ENGINEERING DATA TRANSMITTAL

**DECISION DOCUMENT FOR THE
FINAL DISPOSITION OF
CESIUM AND STRONTIUM
CAPSULES**

HNF-SD-WM-RPT-294
Revision 0

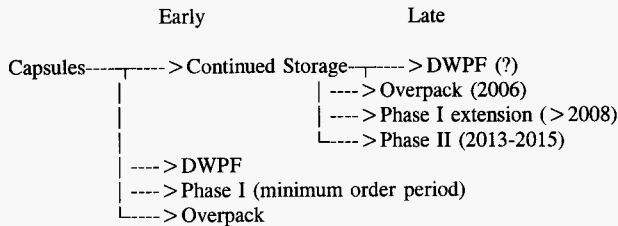
Ken Gasper then noted that Steve Schaus' diagram on the white board (see below) had the DWPF option in Phase I only. He questioned this because he did not believe it proper that DWPF be ruled out even if it was concluded that earlier processing of the capsules was not better because of impacts on Phase I.

Steve stated that he did this because the DWPF option was to be considered only as an early out option. Also since DWPF operations are scheduled to be completed by 2016, waiting will leave less material to blend the capsule contents with. Ken countered by stating that if Phase II fails or no HLW contract is granted in Phase I, DWPF may be THE option. Luc de Lamartinié then stated that the document should address the impacts schedule changes will have on the recommendation. Langdon Holton then drew the following figure on the white board. He stated that this logic would preclude the use of Phase I processing during the minimum order quantity period.
